**FC9103**  
**/A**  
**/B**  
**/C**

Philips Domestic Appliances and Personal Care

# Service Manual

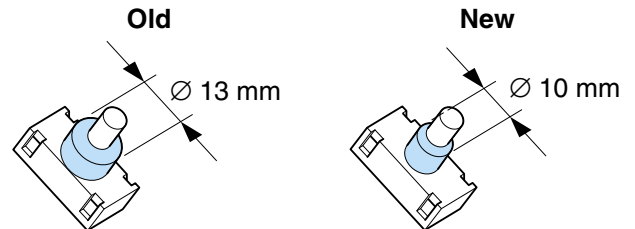
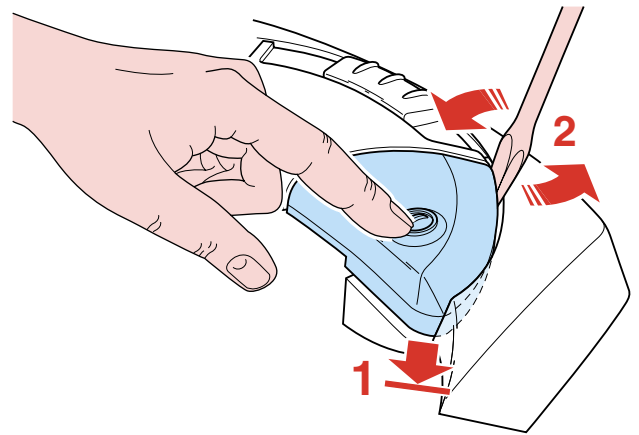
- Due to introduction of a **new switch** (item 11) 0320 onwards, which is not interchangeable with the old switch soldered on the PCB (item 12).
- The switch lever assy (item 11a) is also modified.

To recognize the switches:

To replace the knobs:

New spares are:

11	Switch soldered version	- 4322 006 50600
11a	Switch lever assy	- 4322 009 08980
parts of 15	Switch and Cord winder knob	- 4322 009 09000
